**48-HOUR MATERIALS**

**Public Comments**

**From:** Dr. Susan Chaudoir <edu.chaudoir@gmail.com>  
**Sent:** Monday, March 11, 2019 12:38 PM  
**To:** Somerfeldt, Cheryl; Brito, Russell D.  
**Cc:** Steven Siegel  
**Subject:** PR-2018-001402: Submit to the record: 48-hour rule

**From:** Ellen Barber <ellen@condensedlight.com>  
**Sent:** Monday, March 11, 2019 2:30 PM  
**To:** Somerfeldt, Cheryl; Brito, Russell D.  
**Subject:** EPC Project #2018-001402 (Hearing Date: March 14, 2019)

**Sheet 1 of the site plan correctly shows Cluster A open space required as 3.24 acres, but falsely states open space provided is 3.31 acres**

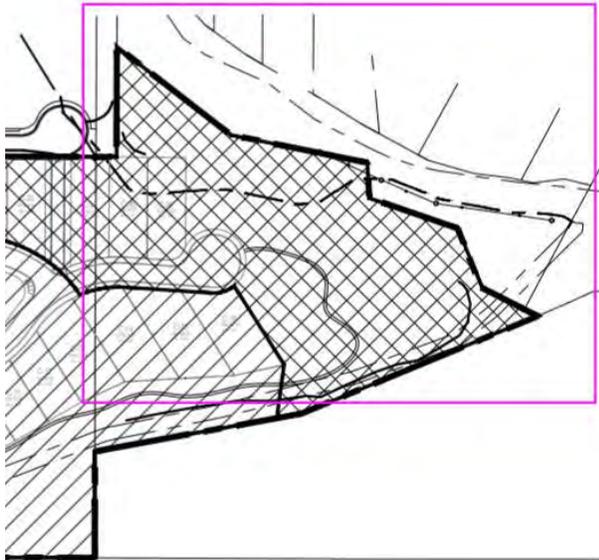
**The actual open space provided for Cluster A appears to be:  
2.33 acres.**

**“Required drainage facilities or land within an easement for overhead utilities that are not landscaped shall not count toward required usable open space.”** Open Space Definitions: page 480 of the IDO (emphasis added)

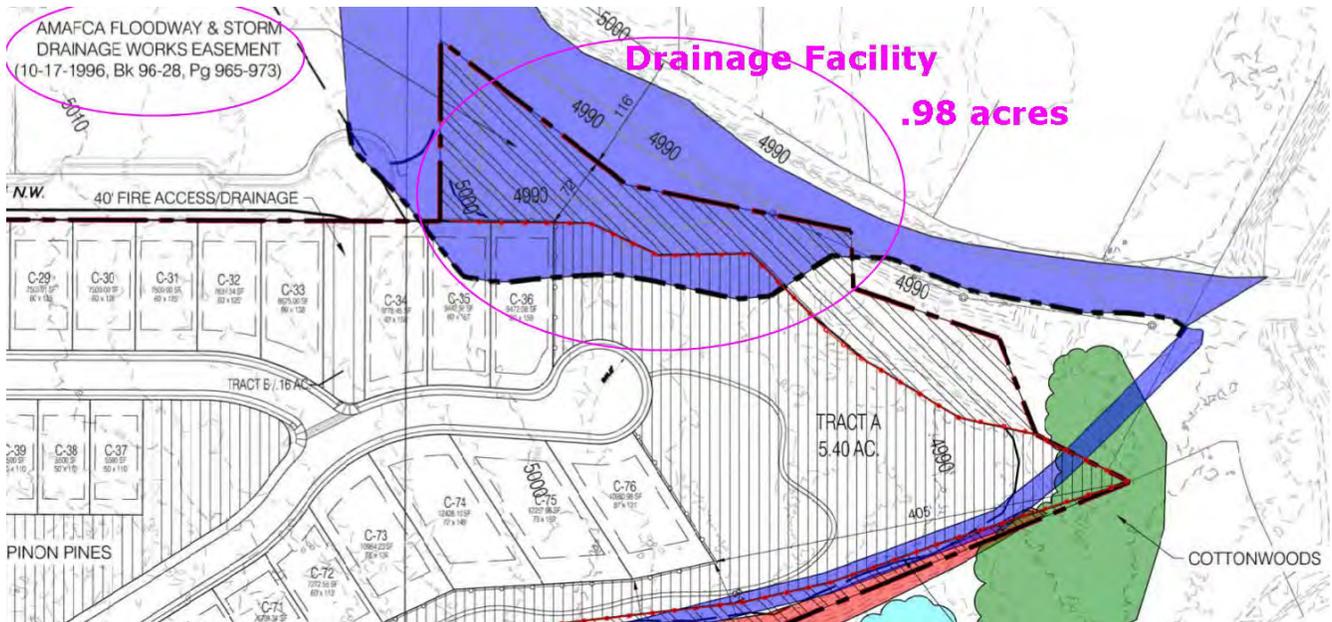
**“Required drainage facilities .... shall not count toward required usable open space.”**

Though the IDO requires open space lots to be on the site plan, Cluster A open space is **NOT** clearly delineated as a separate lot on this site plan. The site plan claims open space provided to be 3.31 acres, but **includes** the AMAFCA drainage easement of **.98 acres**. Excluding the drainage facility, the actual open space provided is only **2.33 acres**.

**Per the IDO, the site plan does NOT provide the required usable, common open space.**

**The site plan common open space provided is deficient by .91 acres.**
